1995 EXCEL SERVICE CENTER DRAINAGE
REPORT

Project 18 Acre Excel Site, Addison	Conference Date 08/24/95
Client Wilcox Realty Group	Issue Date
Conference Location City of Addison Service Center	Project No. 3027-01

**Excel Telecommunications Center
Construction Plan Review
November 27, 1995**

RE: Excel Service Center

**INLET DETAIL
ON ADDISON ROAD**

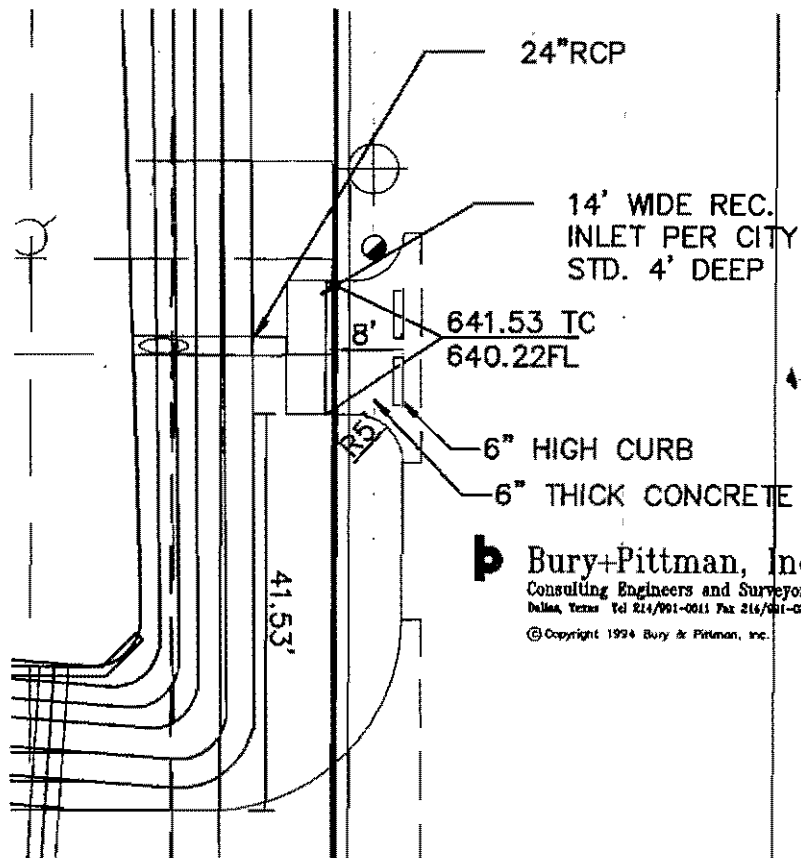
We need something for our files showing the revised inlet on Addison Road to be approved. I have drawn up the attached sketch showing what you proposed (match inlet at Addison Road and Beltline).
